Technical Letter Report
[TLR-RES/DE/REB-2022-01]

Review of Code Cases Permitting Use of Nickel-Based Alloy 617 in Conjunction with ASME Section III, Division 5

Date: January 31, 2022

Figure 2-1 Thermal conductivity of Alloy 617 from INL, 2021b

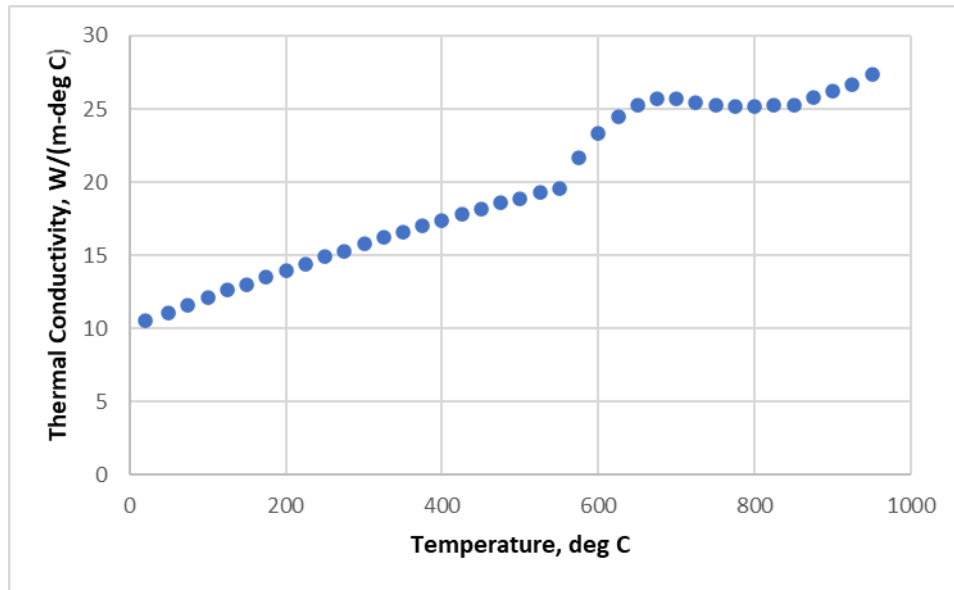
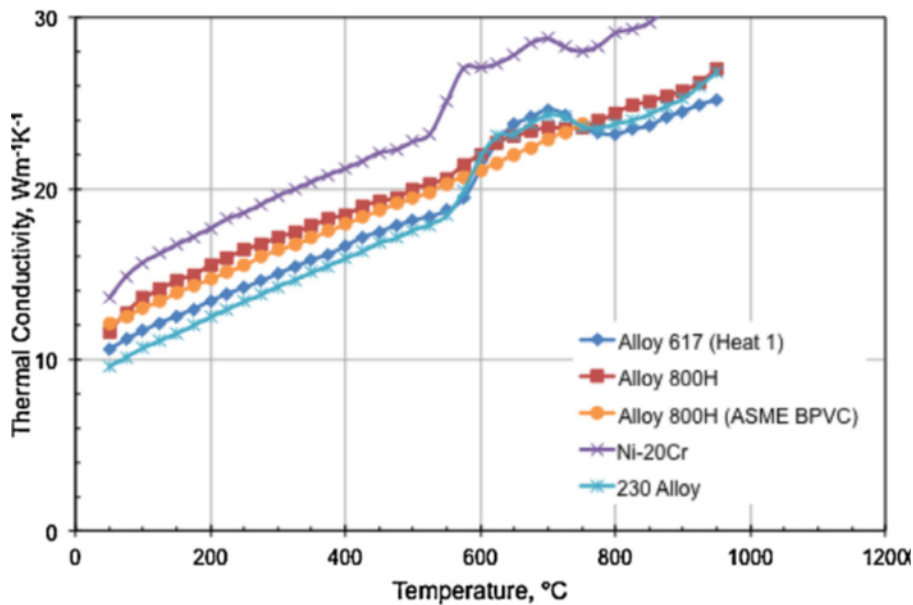
INL, 2021b, provides the technical basis for the proposed thermal conductivity and thermal diffusivity values. The staff notes that N-872 provides thermal conductivity and thermal diffusivity values from 20-425 degrees C (70-800 degrees F). However, the technical basis in INL, 2021b provides proposed values of thermal conductivity and thermal diffusivity from 20-1000 degrees C (70-1800 degrees F). Both thermal conductivity and thermal diffusivity were based on physical measurements. Polynomial fits to the data were used to determine the relationship of thermal conductivity to temperature and thermal diffusivity to temperature. Both thermal diffusivity and thermal conductivity show an essentially linear relationship to temperature except in the temperature range of about 600-800 degrees C (1112-1472 degrees F), where non-monotonic behavior is observed, with a peak at around 1,300 degrees F (700 degrees C)(Figure 2-1).

However, Rabin et. al., 2013, shows actual test data for several nickel-based alloys, including Alloy 230, which shows similar non-monotonic behavior (Figure 2-2). INL, 2021b also showed a comparison of the proposed thermal conductivity values to the values for two other nickel-based alloys (Alloy 230 and Hastelloy-X) from Section II-D Table TCD. The proposed values are in good agreement with the other two alloys except that the Section II-D values for the other two alloys do not reflect the non-monotonic behavior.

INL, 2021b notes that although the deviation is not shown in either the vendor data for Alloy 617 or in Section II-D for the other nickel solid solutions, the magnitude of the local peak in conductivity is nearly 20% compared to a monotonic curve, and the local peak lies within the temperature range where it is anticipated that Alloy 617 will be used for nuclear heat exchanger design. Rabin et. al, 2013, ascribes this behavior primarily to short-range order/disorder phenomena known to occur in the nickel-chromium system. INL, 2021b states that it therefore seems reasonable to include the non-monotonic behavior in the proposed thermal properties. The staff notes that the non-monotonic behavior occurs at temperatures above 800 degrees F (425 degrees C); therefore, this behavior does not affect the values of thermal diffusivity and thermal conductivity included in Code Case N-872, which only includes values up to 800 degrees F (425 degrees C). However, the non-monotonic behavior is pertinent to the thermal properties in Code Case N-898, since the same technical basis is used for the thermal properties in the high-temperature code case.

The staff finds the proposed thermal conductivity and thermal diffusivity acceptable because the values are based on physical measurements, the mathematical fit to the data seems reasonable, and a plausible physical explanation has been given for the non-monotonic behavior occurring in the 600-800 degrees C (1112-1472 degrees F).

Figure 3-1 Actual vs. expected rupture stress for weld tests reported in INL, 2021h, all test temperatures

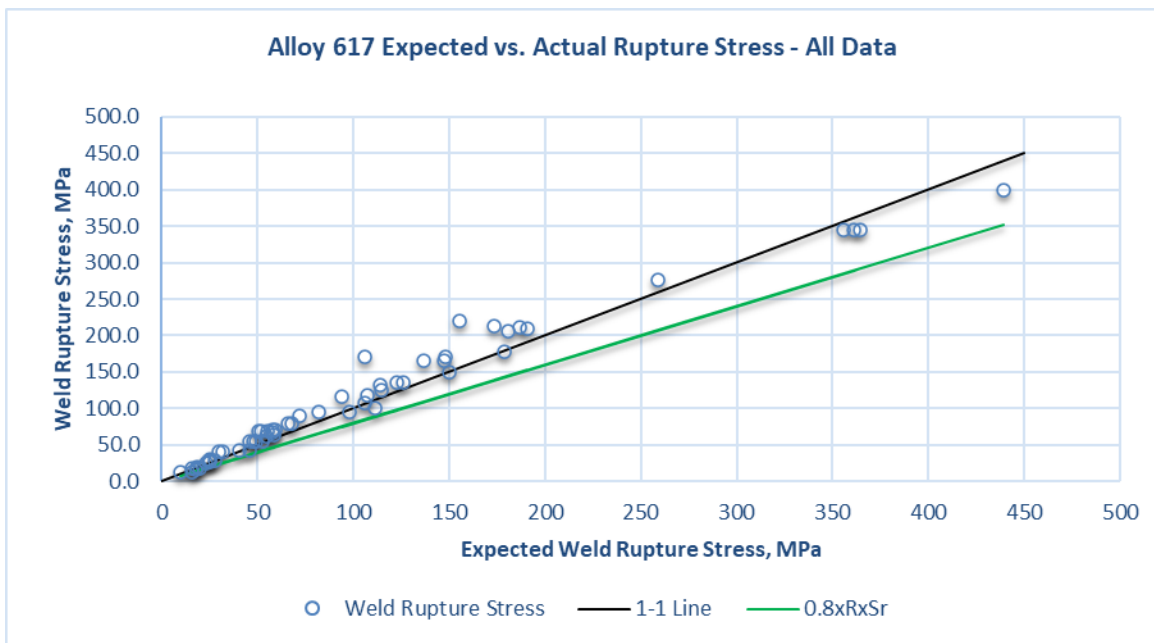
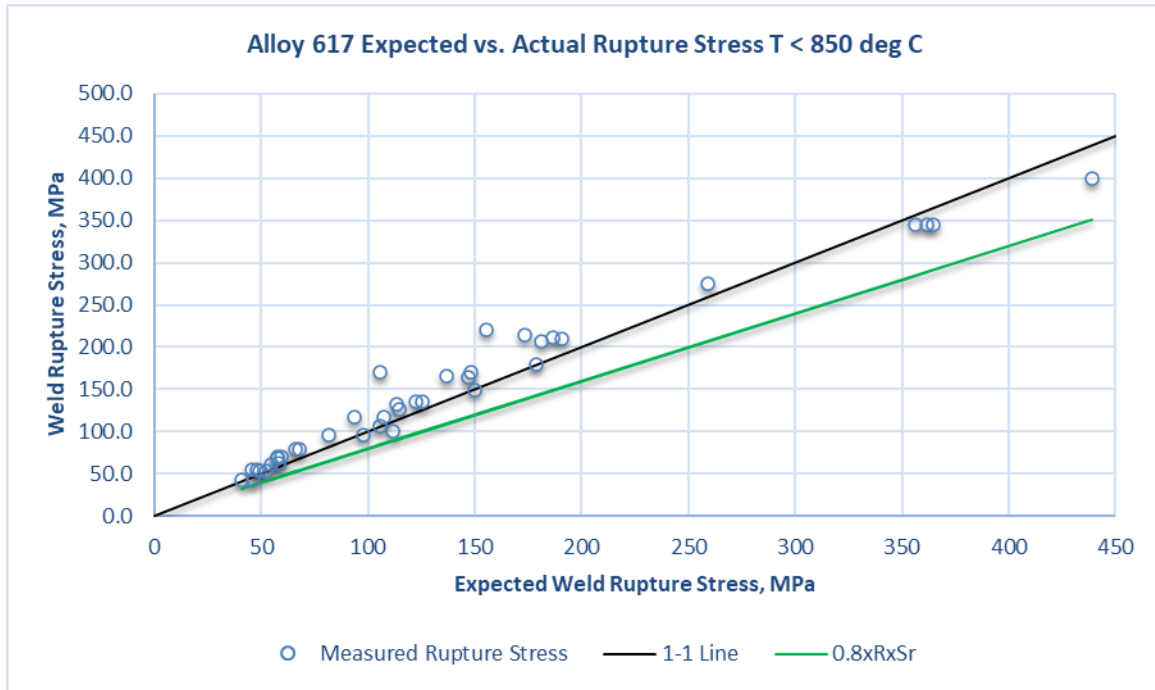
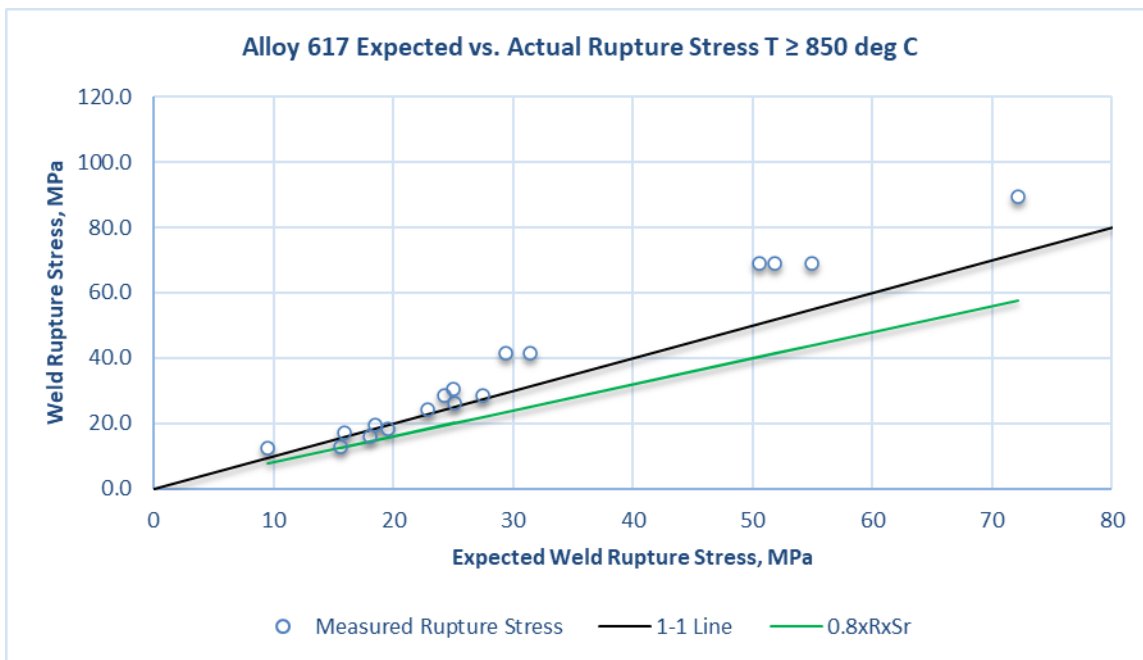
Based on all the weld creep-rupture data for transverse specimens from GTAW welds, the technical basis determined SRFs of 1.0 for GTAW weldments for temperatures < 1,562 degrees F (850 degrees C). and a SRF of 0.85 at temperatures \geq 1,562 degrees F (850 degrees C). INL, 2021h indicates these factors are considered a conservative representation of the data. Figure 8 of the Background Document for the SRFs in INL, 2021h shows the individual calculated SRFs as a function of temperature, with the recommended 1.0 and 0.85 lines shown on the graph. A few data points (4 of 19) fall below the 1.0 line at temperatures \leq 1,562 degrees F (850 degrees C), with the remaining 15 points located above the line. For temperatures > 1,562 degrees F (850 degrees C) up the maximum use temperature of 1,742 degrees F (950 degrees C), only two of twenty points fall below the 0.85 line.

The staff reviewed the determination of the SRFs, and notes that although a few SRFs for individual tests fell below the SRFs recommended in the Code Case technical basis, the additional factor of 0.8 by which the base metal S_r values are multiplied in Section III-5, Paragraph HBB-3221 provides an additional margin of conservatism. Figure 3-1 is a graph of the actual versus measured weld rupture stress from the test data used to develop the code case SRFs. The expected values are determined based on the expected base metal rupture stress, determined using the base metal LMP correlation for S_r multiplied by the applicable SRF (either 1 or 0.85). Measured weld rupture values falling above the black (one-to-one) line indicate actual values higher than expected rupture values, while those falling below indicate actual rupture values less than the expected rupture values. The green line represents the expected value multiplied by 0.8. It can be seen that the green line is below, and thus bounds all of the measured data. Figure 3-2 shows the weld rupture data for tests conducted at temperatures less than 1,562 degrees F (850 degrees C), and Figure 3-3 shows the weld rupture data for tests conducted at temperatures greater than or equal to 1,562 degrees F (850 degrees C). Figure 3-2 and 3-3 also show all the data being bounded by 0.8 times the expected rupture value. Therefore, the additional factor of 0.8 in HBB-3221 results in 100% of the test data being bounded, indicating that the proposed SRFs are sufficiently conservative for design purposes.

Figure 3-4 Creep-fatigue damage envelope for Alloy 617.

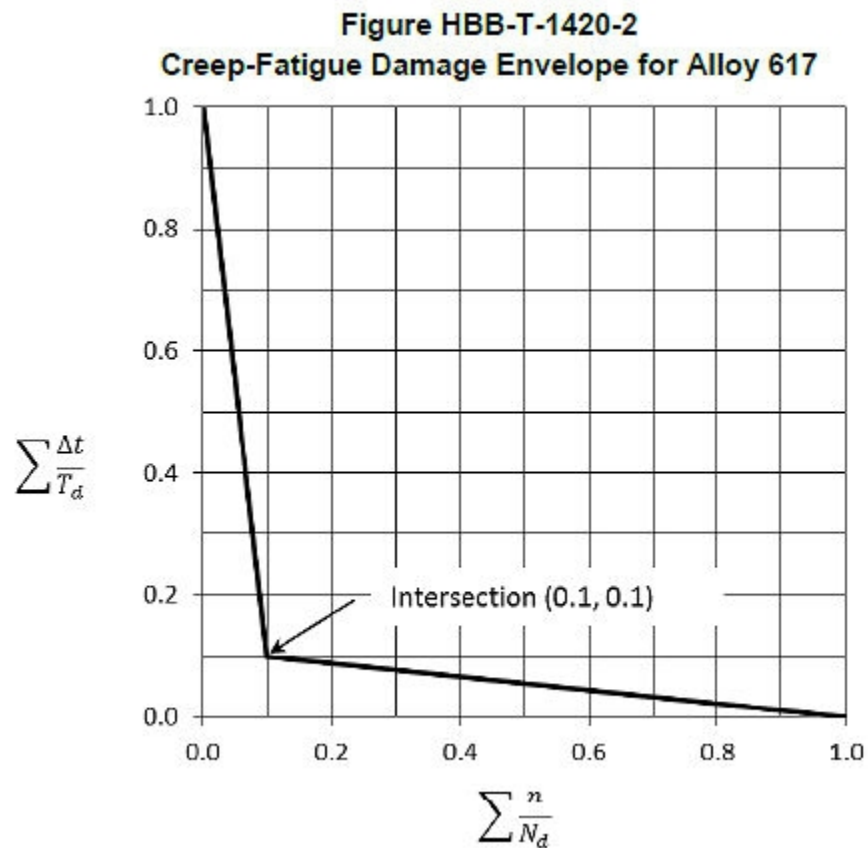
The bilinear creep-fatigue interaction curve for use with Alloy 617 using the creep-fatigue damage equation of HBB-T-1411 is defined here. The interaction diagram is shown in Figure 3-

2. Creep damage is accumulated on the vertical axis and fatigue damage is accumulated on the horizontal axis. The combined damage must be below the bilinear line.

The original test data used to verify the interaction rule with intersection point (0.1, 0.1) for Alloy 617 was developed by Corum and Blass (Corum et. al., 1991) based on an early set of test data compiled by Yukawa (Yukawa, 1991). In addition, INL, 2021p, which is based on the work with data published in Wright et. al., 2016 shows that 15 of 103 data points are outside the failure locus diagram (e.g., to the right or above the lines on Figure 2-2) (see Figures 11-13 in Wright et. al., 2016) for many test cases. On the fatigue axis, a few points are on or inside the failure locus diagram in Wright et. al., 2016. The staff finds that having a few points inside the line does not indicate the creep-fatigue diagram is unacceptable because, as stated in INL, 2021p, the creep-fatigue damage envelope generally represents the average trend of the interaction between the creep damage and fatigue damage. McMurtrey et. al., 2018 shows similar

conservative comparisons to the failure envelope. Finally, Dewa, et. al., 2018 also show that creep-fatigue test data developed in Korea all fall outside the Alloy 617 failure envelope for the proposed interaction diagram for Alloy 617.

This review recommends that HBB-T-1420 be accepted for the reasons discussed in the previous paragraph because the choice of the interaction diagram is very conservative as seen with the discussion of predictions using the model with test data discussed in Section 3.8.23.8.4. The validity of the inelastic constitutive models must be demonstrated to produce accurate inelastic response. The creep-fatigue damage envelope, with damage intersection point (0.1, 0.1), proposed for Alloy 617, will provide conservative predictions when used with the safety factors. This definition of the failure locus was originally proposed by Corum and Blass (1991) in the original attempt to put together a code case for Alloy 617 based on test data compiled from sources at the time and is validated in the work at INL and references cited therein (Cabet et. al., 2013, Wright et. al., 2016, Wright et. al., 2018) by comparison to extensive creep-fatigue test

Figure I-2 Calculated ISSC for Alloy 617 at 1,749 degrees F (954 degrees C).

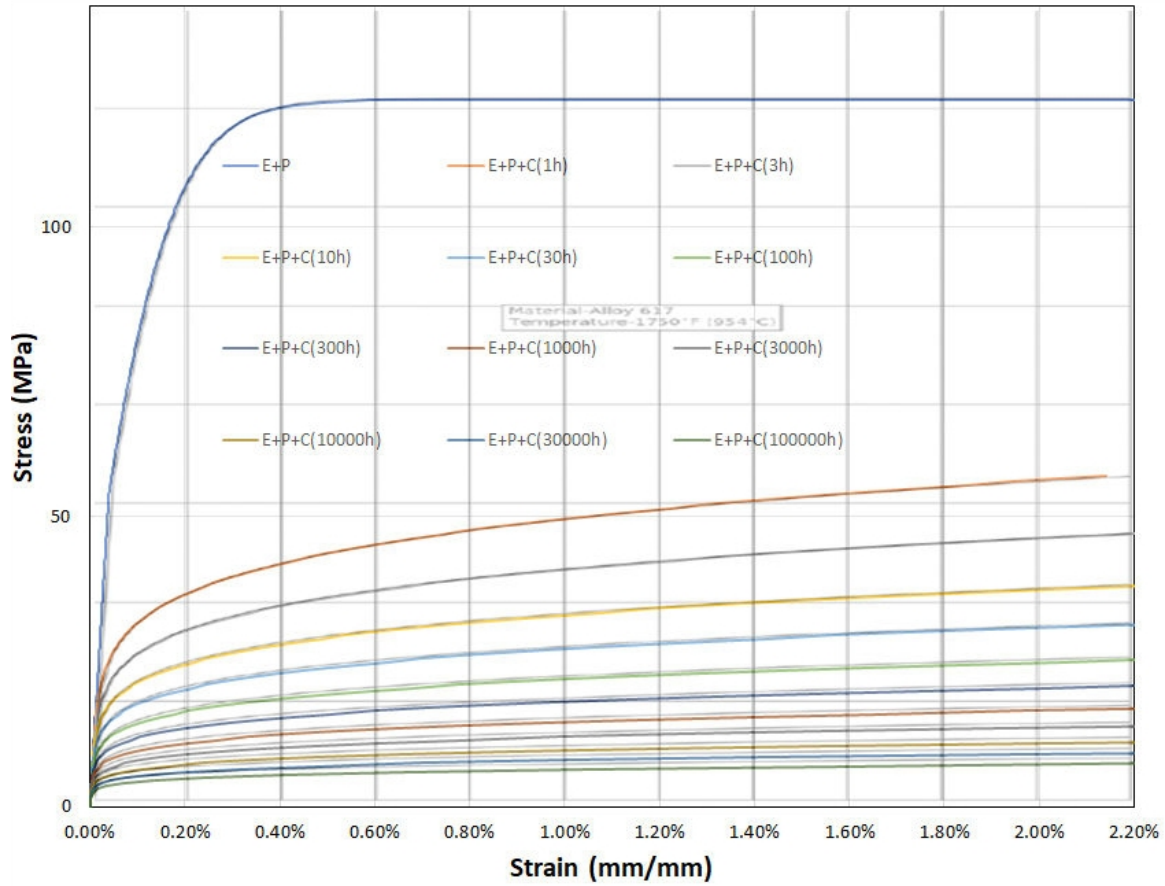
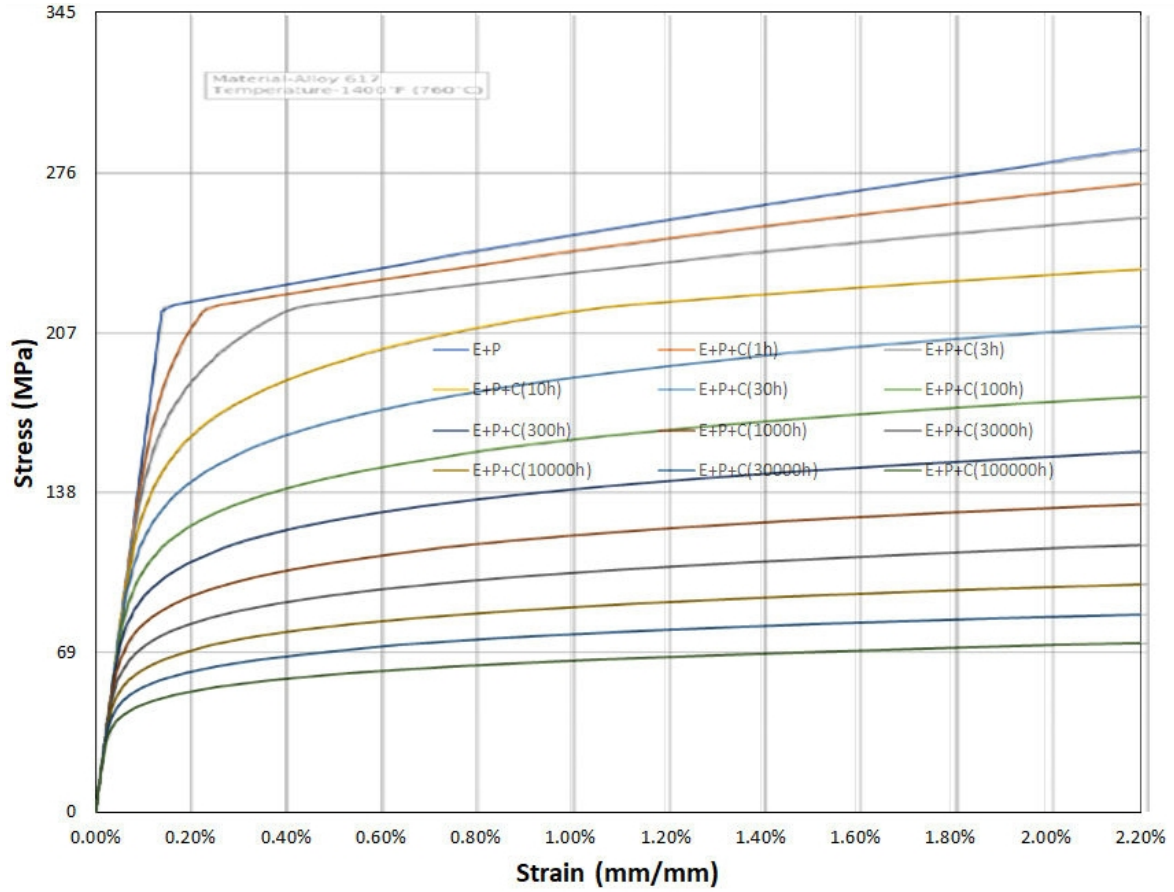
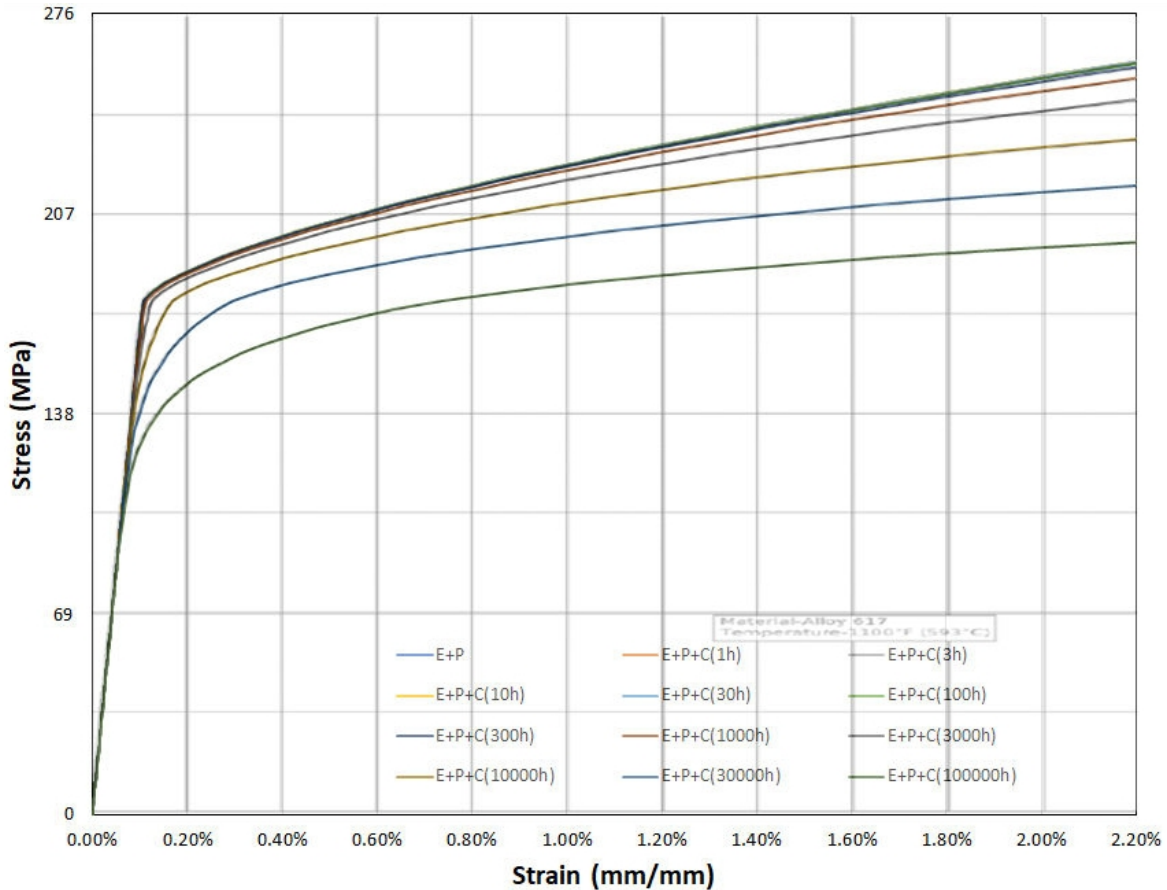
The ISSC curves were reproduced and compared directly with the curves in INL, 2021o. Some of these will be shown below along with some limited data showing that the curves match other data as well. An example curve with comparisons to the code curves are shown in Figures I-2 to I-4 for 1,099, 1400, and 1,749 degrees F (593, 760, and 954 degrees C), respectively. These figures show the ISSC curves from the code case to the curves developed from the spreadsheet and they lay on top of each other verifying the mathematical equations provided in the code case. In the following ISSC plots 'E+P' represents the hot tensile curve (no creep) and 'E+P+C' included creep effects and depends on time.

The calculated isochronous stress-strain curve is in color and the Record number curve is in gray. They are identical and on top of each other.

The calculated isochronous stress-strain curve is in color and the Record number curve is in gray. They are identical and on top of each other.

The calculated isochronous stress-strain curve is in color and the Record number curve is in gray. They are identical and on top of each other.

Since Code Case N-898 may not be revised to correct this error prior to the publication of this TLR, the staff recommends a limitation on Code Case N-898 that HBB-T-1836, Equation (2)(-b) should be replaced by the equation above.

Figure I-5 Comparison of Code Case N-898 ISSC curve at 1,292 degrees F (700 degree C) to data from Narayanan, et. al., 2017 (Davies) and Knezevic, 2013.

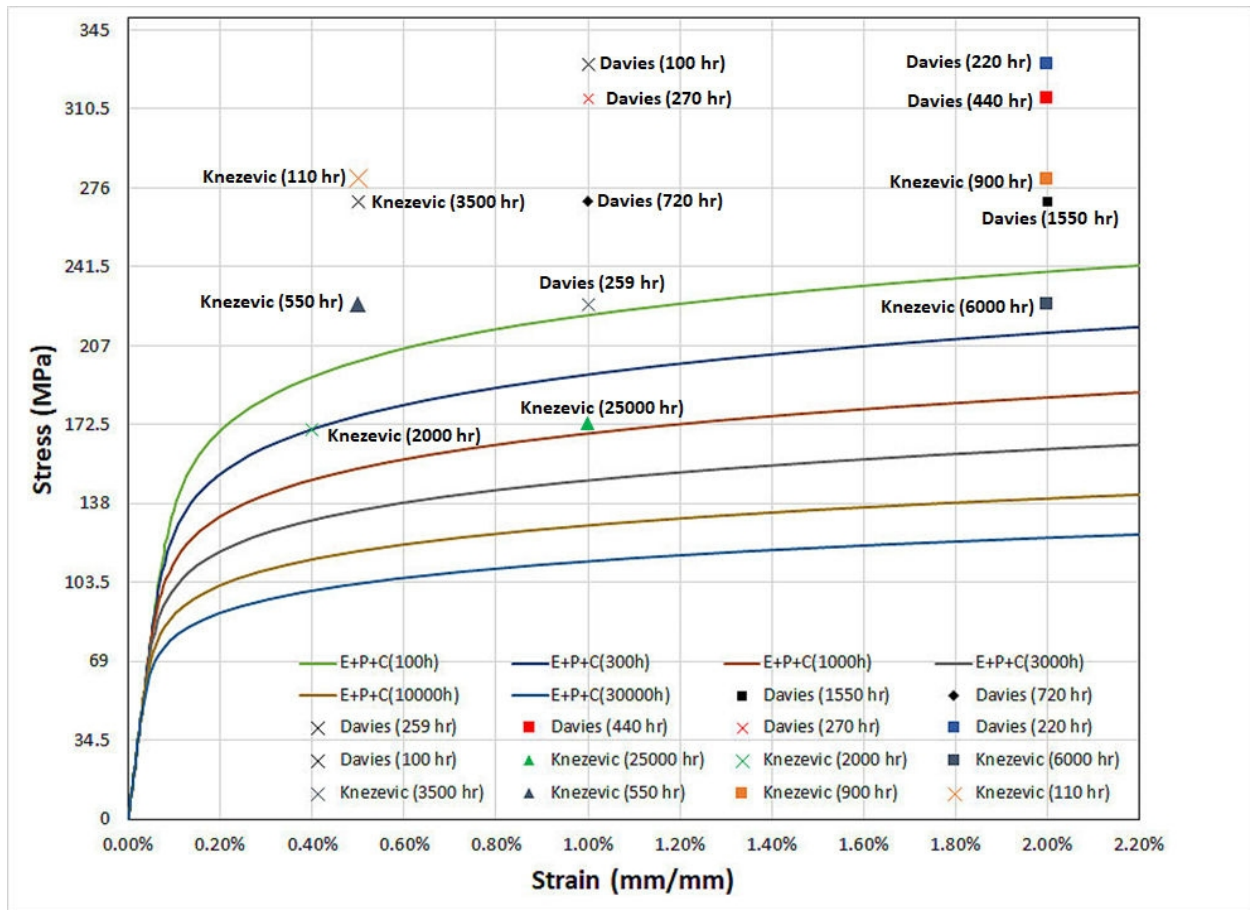
The first set of additional data comes from the Davies group at Imperial College (Narayanan, et. al., 2017). Figure I-5 compares the Davies data with the ISSC curves in the code at 700 degrees C. It is seen that the Davies data points are all above the code ISSC curves indicating

conservatism. In addition, data from Knezevic et. al., 2013 also plotted on this curve for 700 degrees C are also conservative as the points are higher than the corresponding ISSC curve in the code.
